**Permit No: 0312484**

**Nature of Work: 28639 SF ADDITION FOR WAREHOUSE.PARKING AND SITE WORK**

**FINAL REPORT  
CONSTRUCTION OBSERVATION AND TESTING SERVICES  
ATCO PHASE II**  
Diesel Drive  
Sacramento, California  
Reference No. 1424-001.01  
Permit No. 0312484

Re: Atco Rubber Products Addition, 1701 Diesel Dr, Sacramento Ca  
C39-2177  
Permitted Use of Epoxy at Detail C/S2.2

**C** FREE-STANDING SCREEN WALL  
SECTION

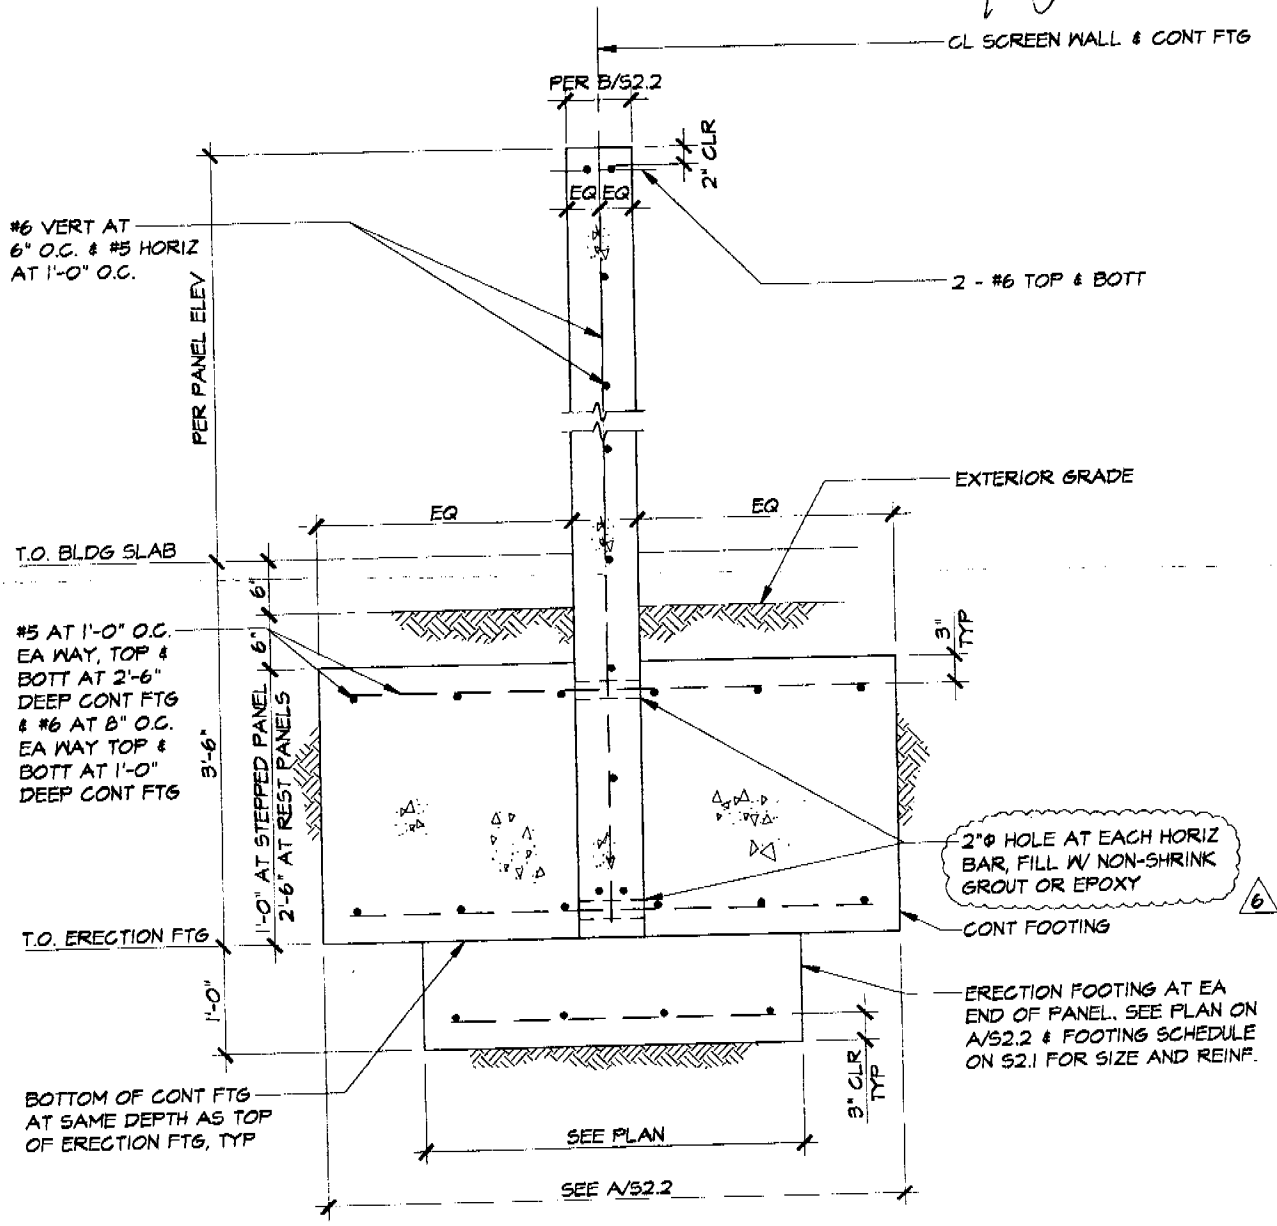
Epoxy substitute is permitted as a substitute for grout at the panel holes within the footing at detail C/S2.2. See attached revised detail.
